Re: **The Parklands Village V2F1 – Site Plan and Plat - Response to Comments (2022-4054-00; 2022-3092-00)**

FIRST TECHNICAL REVIEW

PLANNING DEPARTMENT COMMENTS – DEBORAH BICKMIRE

L-113
SHEET 44

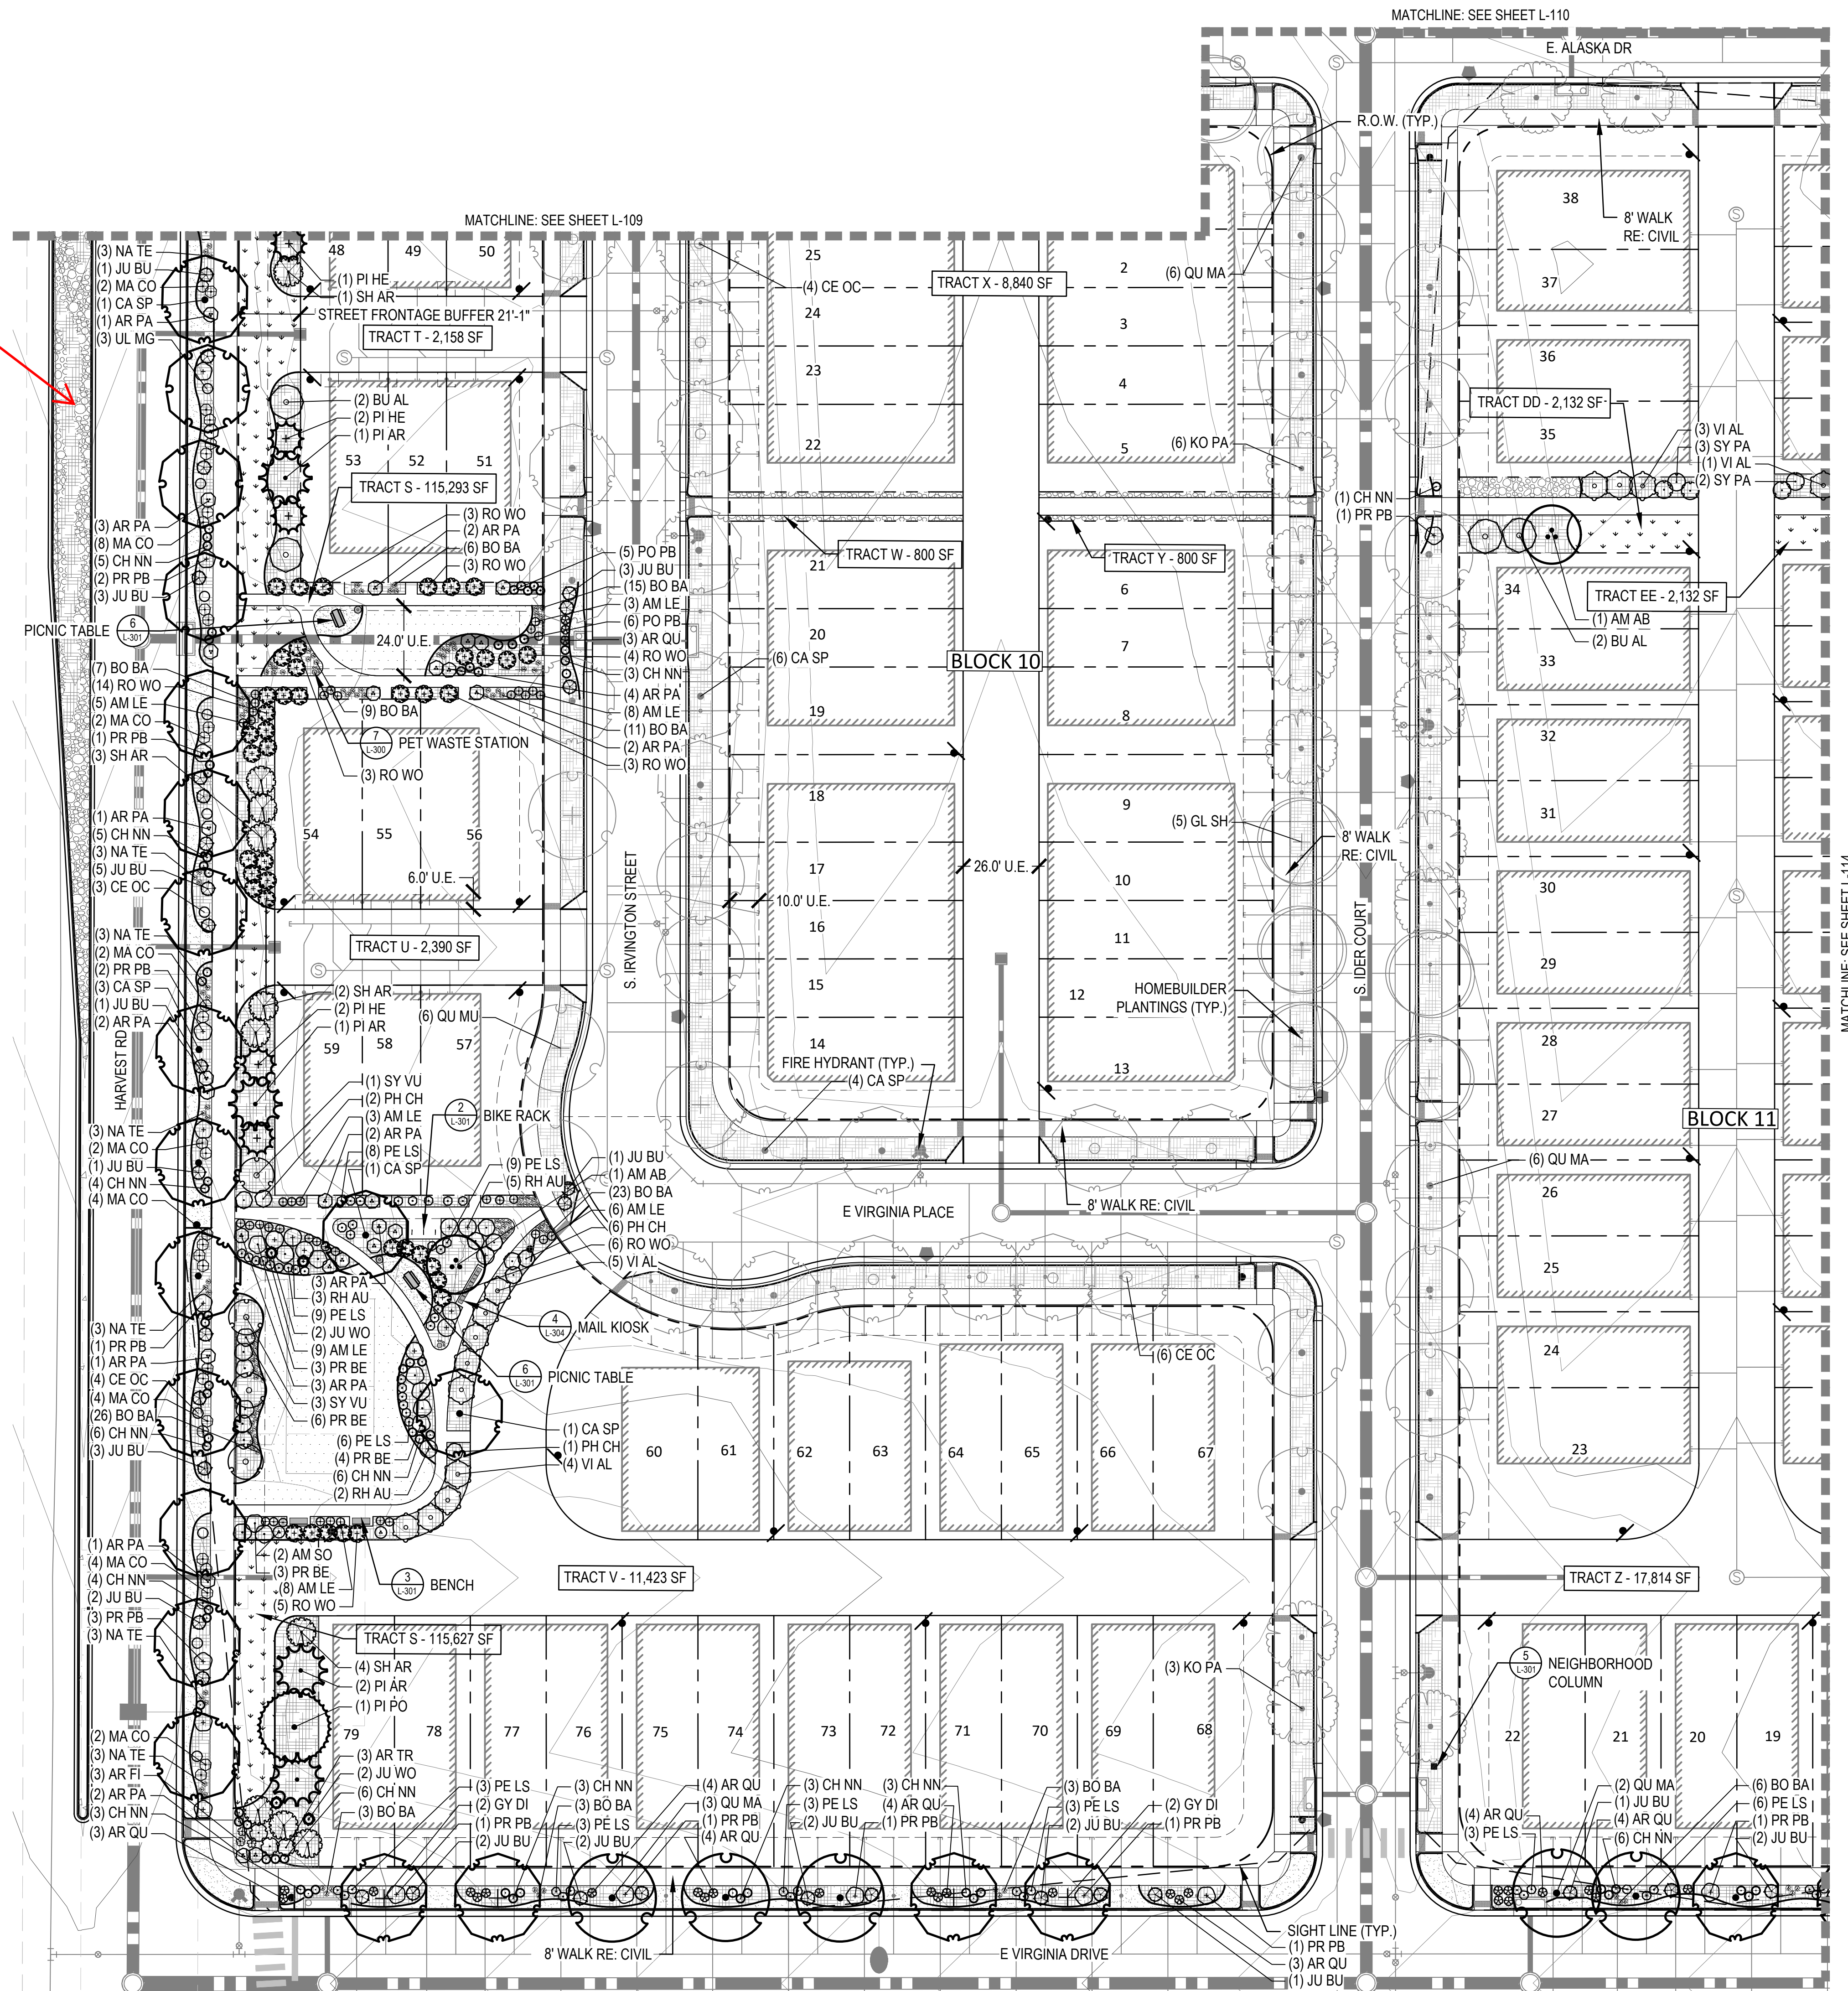
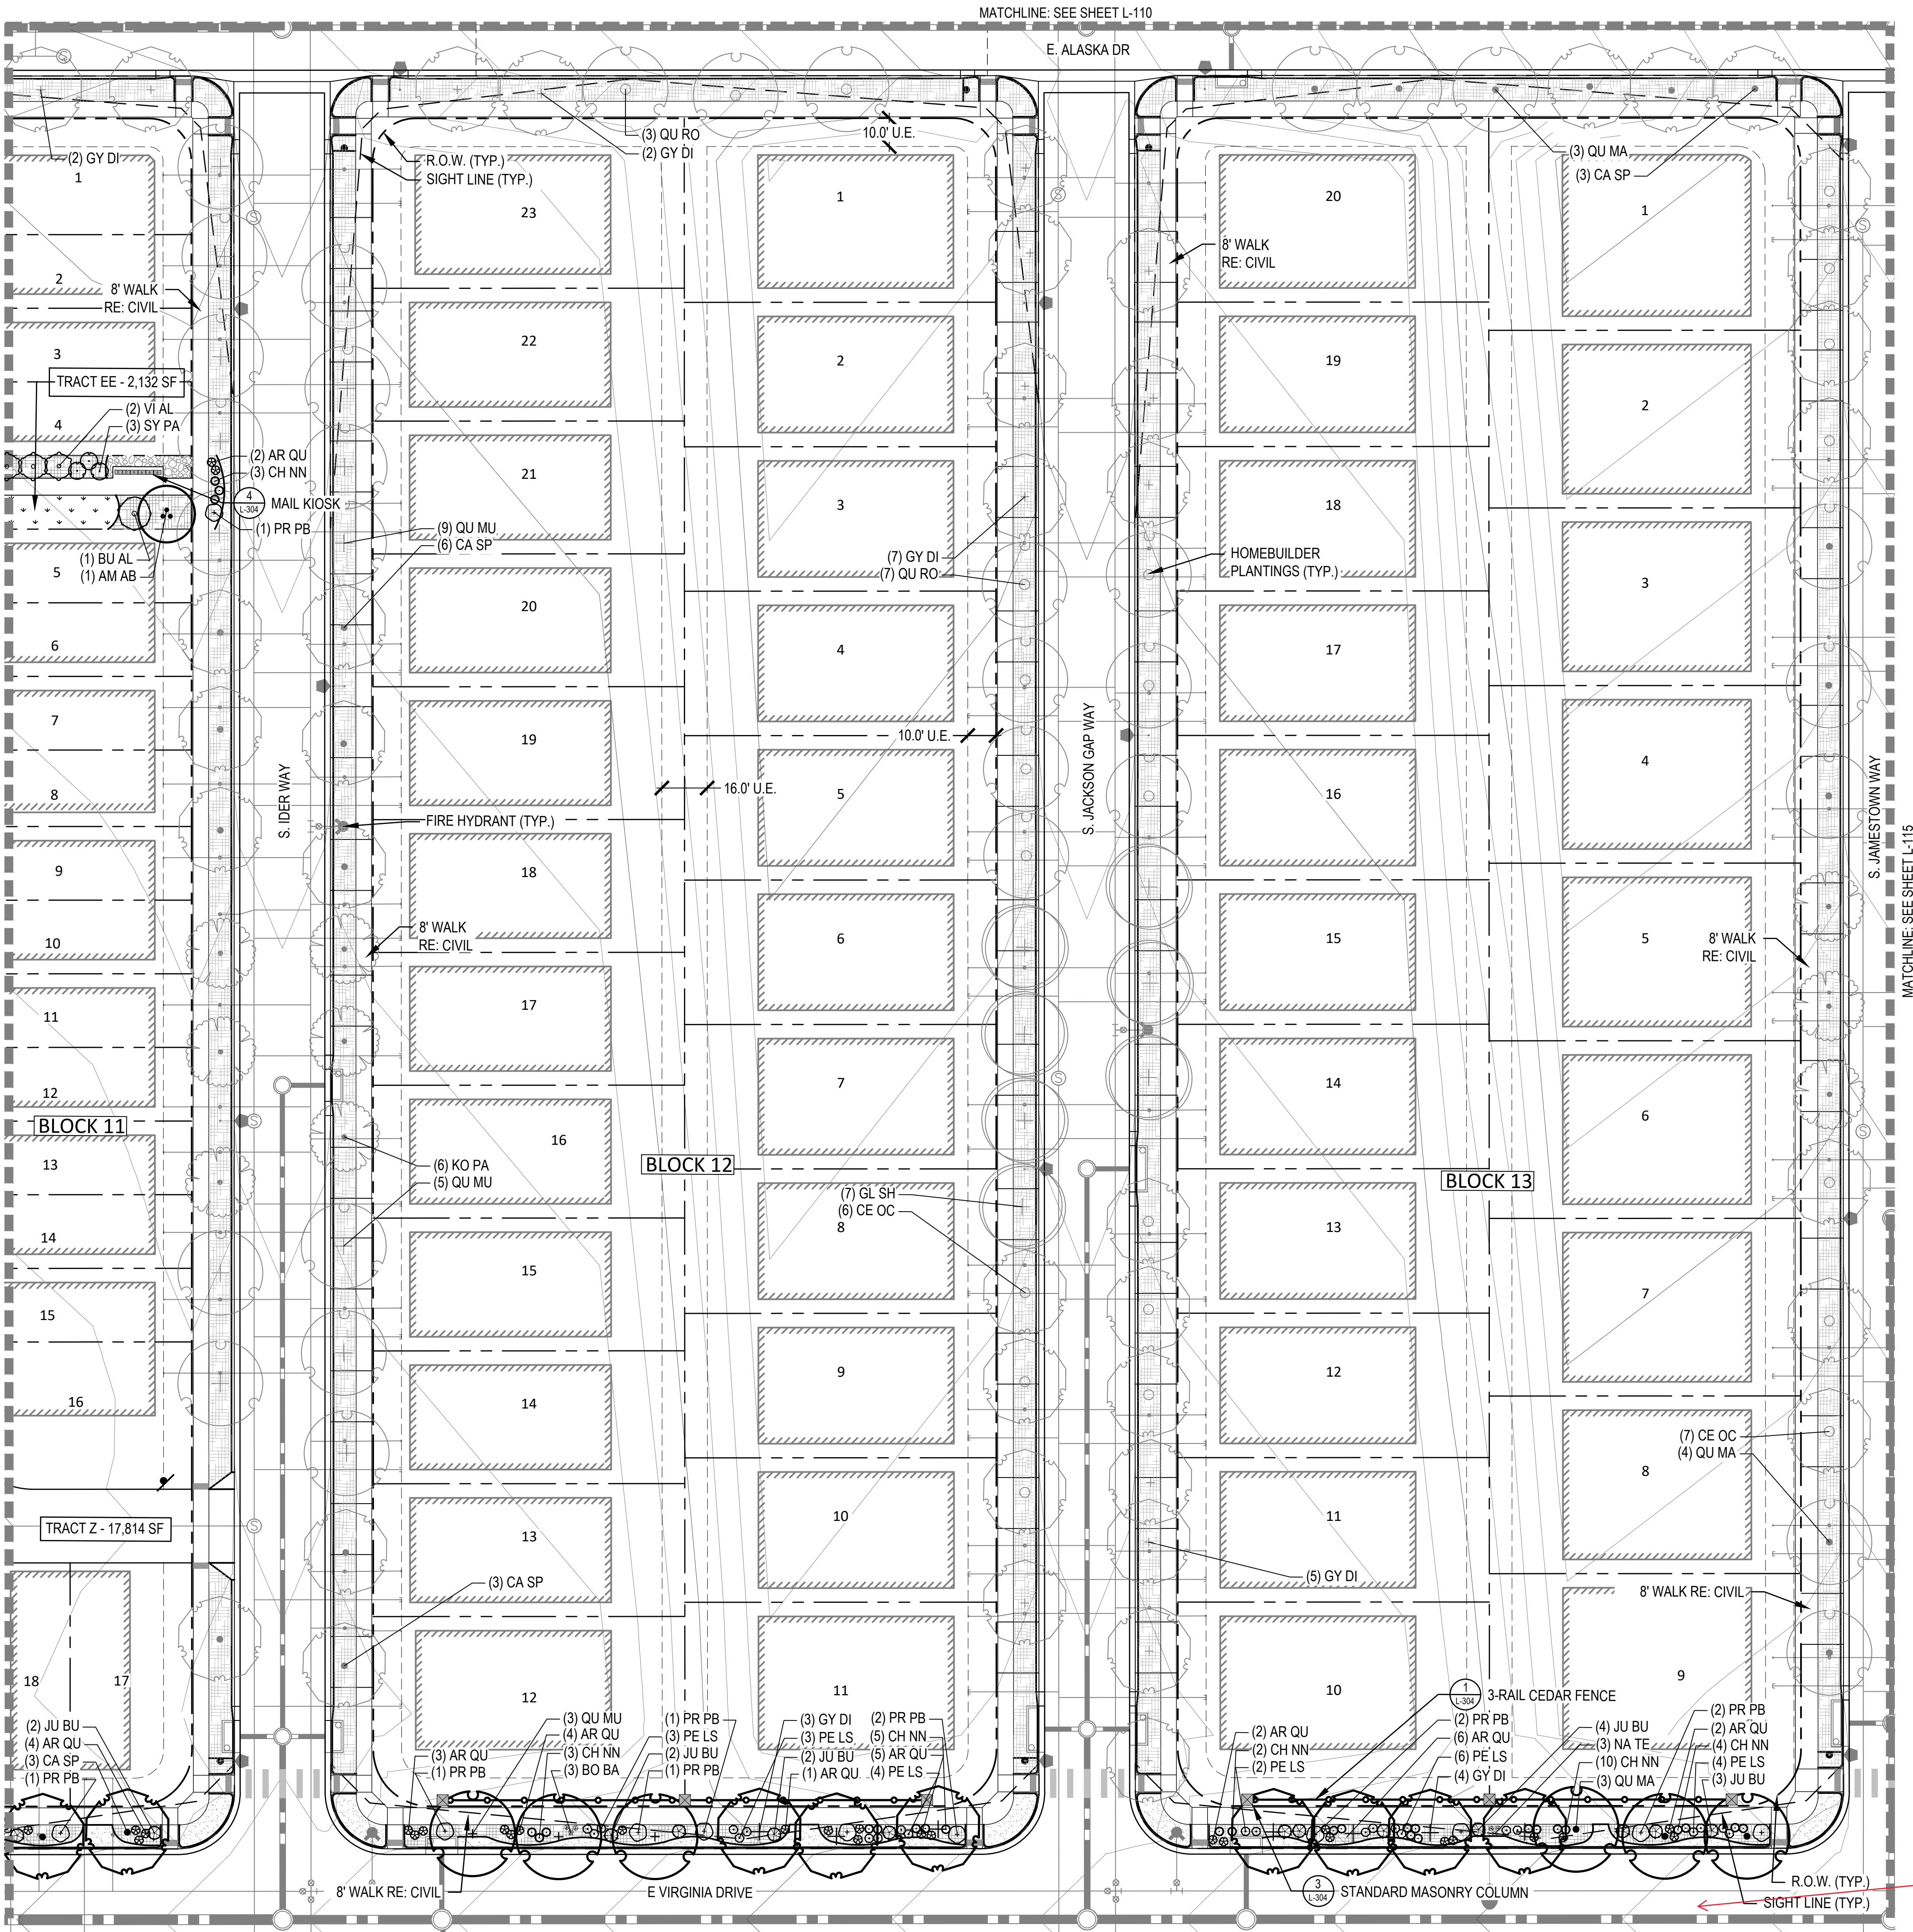
Was the median landscaping provided with a previous ISP or is it being designed in connection with this application? Please provide the Case Number and title if this was previously approved.

Response: Median landscaping has been shown in these plans. Developer will install and HOA will maintain.

SHEET 45

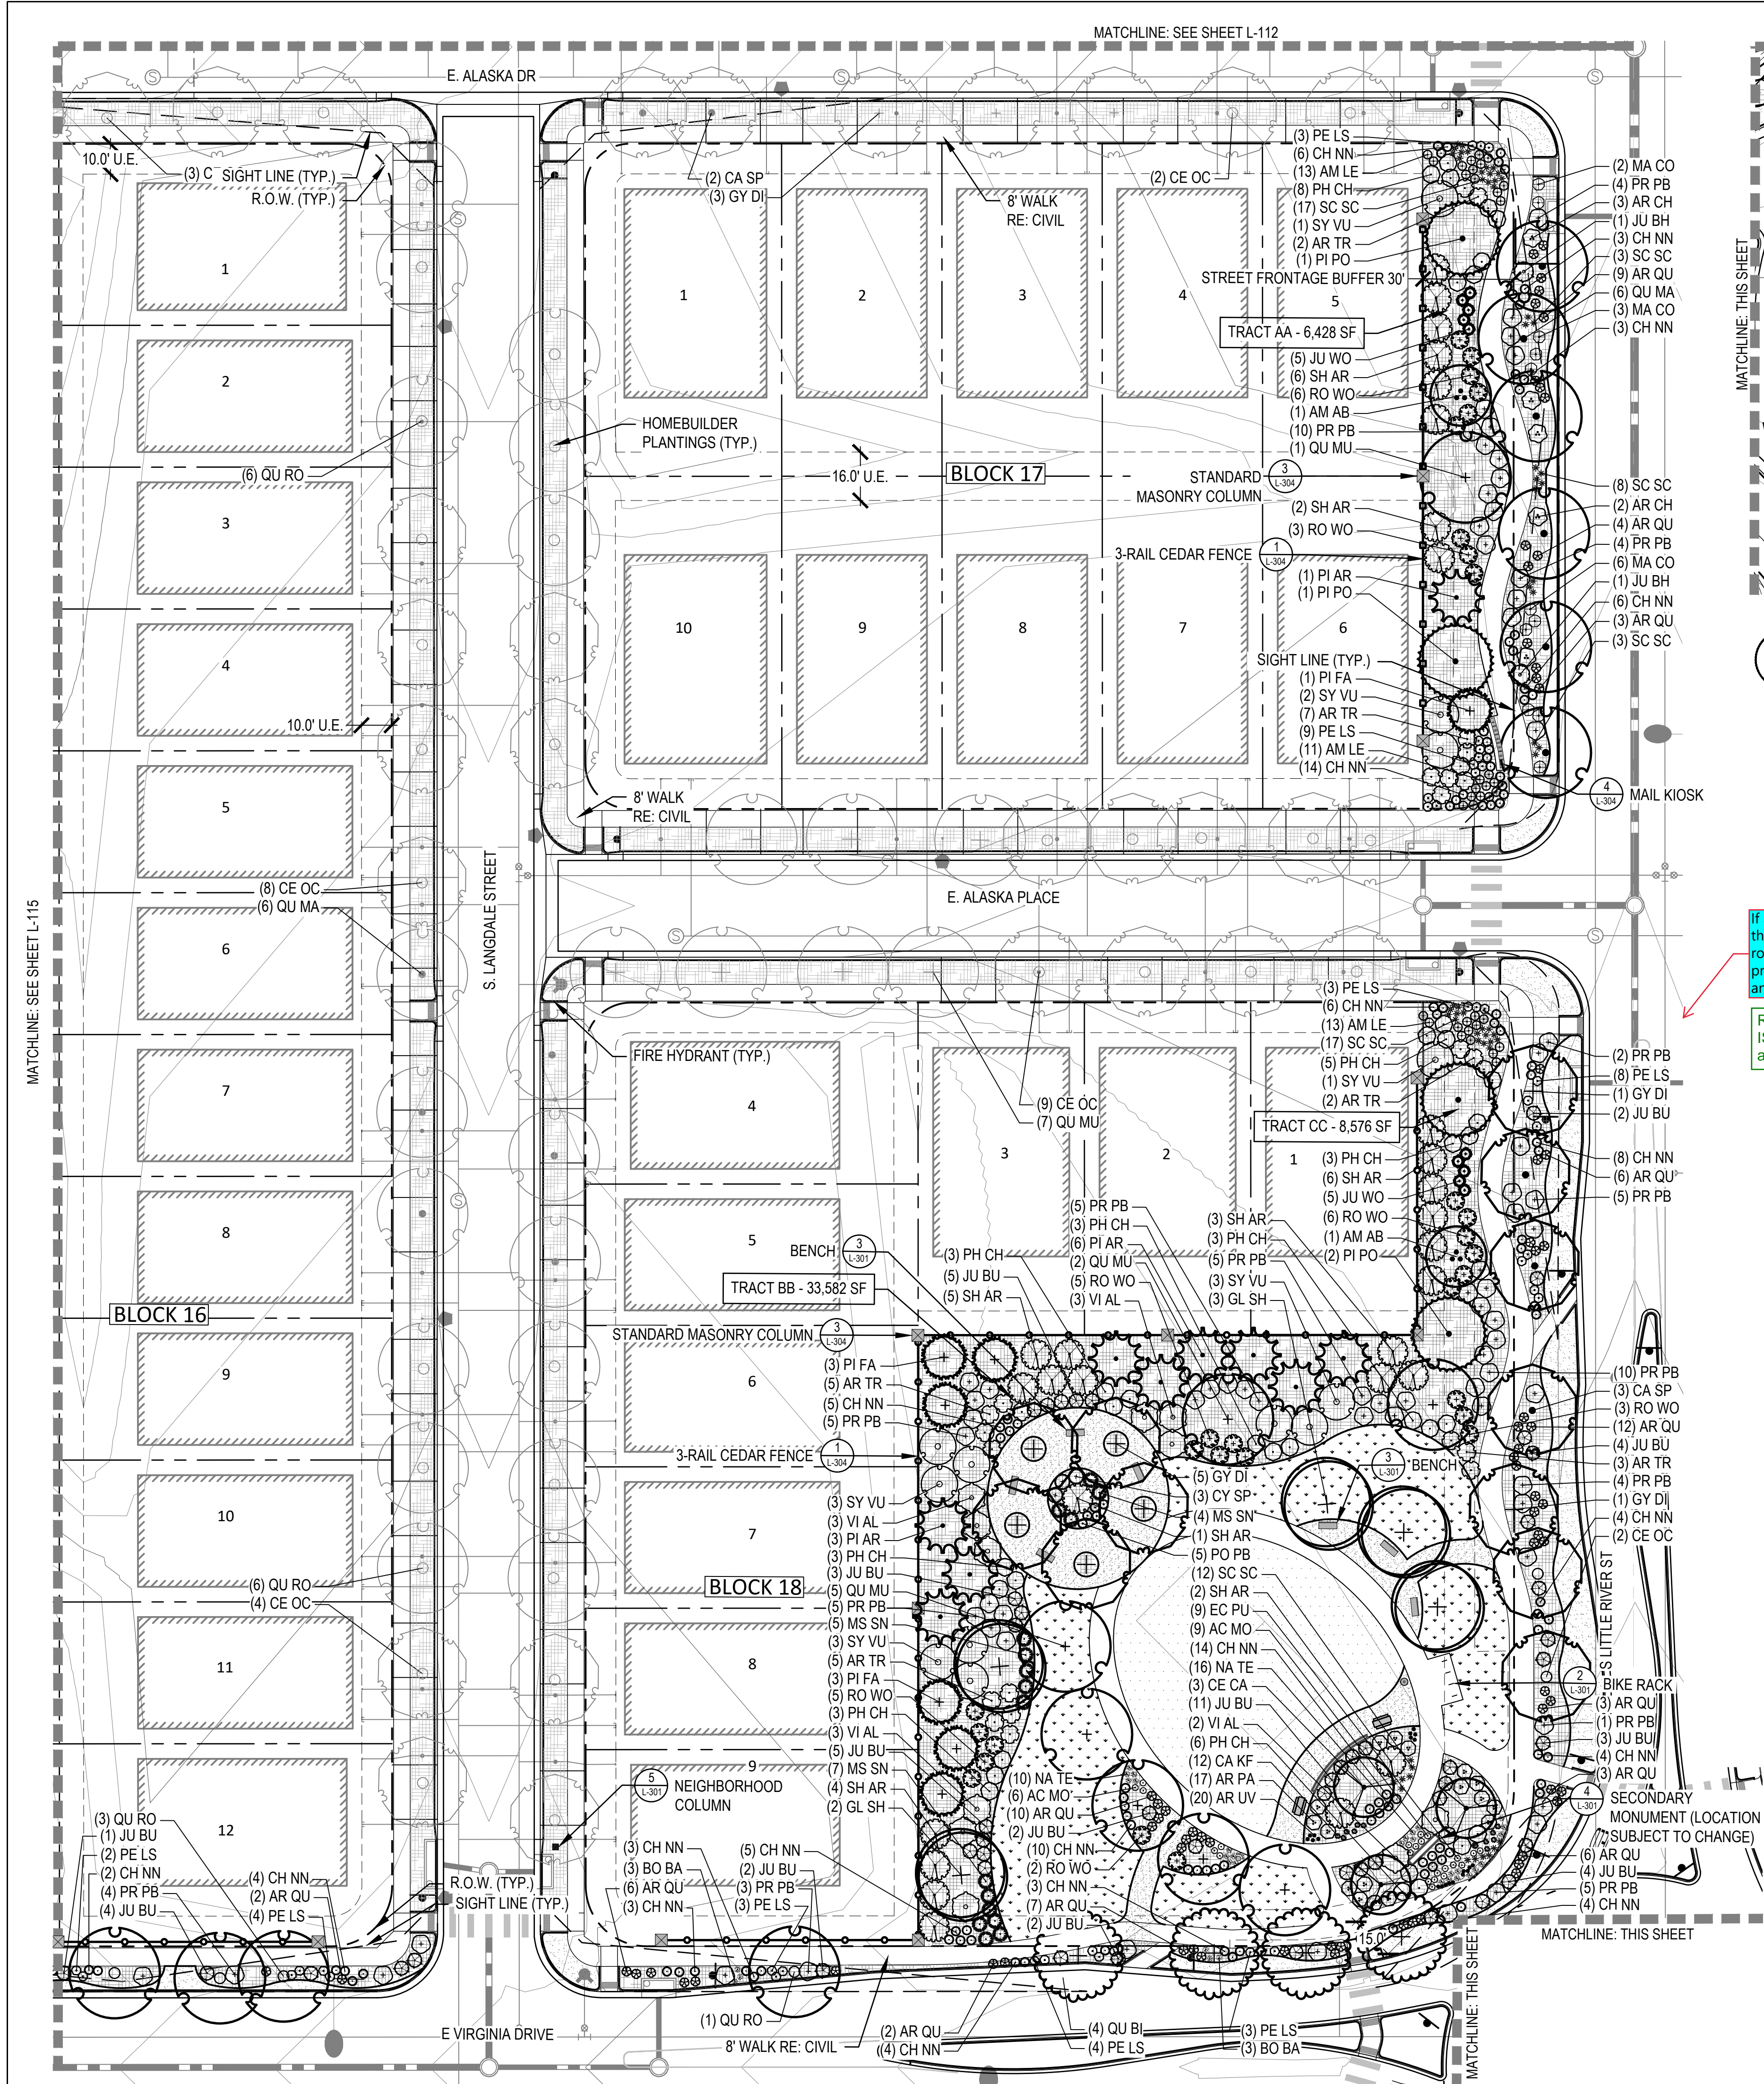
If an ISP # exist for this side of the roadway, please provide the name and CN#.

Response: Available CN and ISP #'s have been provided if applicable.

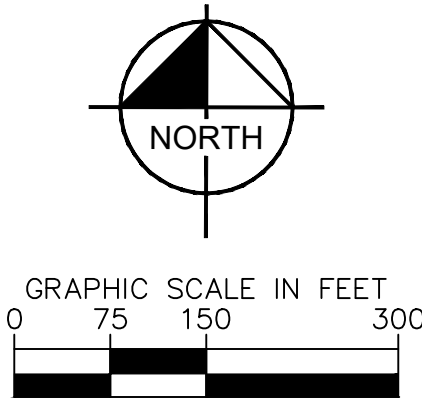
FYI - photometrics are not typically required with site plans. It is reviewed during civil plan review

Noted. On Future Site Plans for Parklands the photometric plans have been removed. Because filing 1 recieved Admin approval with the Photometric plan they have been left on. Comments received and addressed during Civil plans.
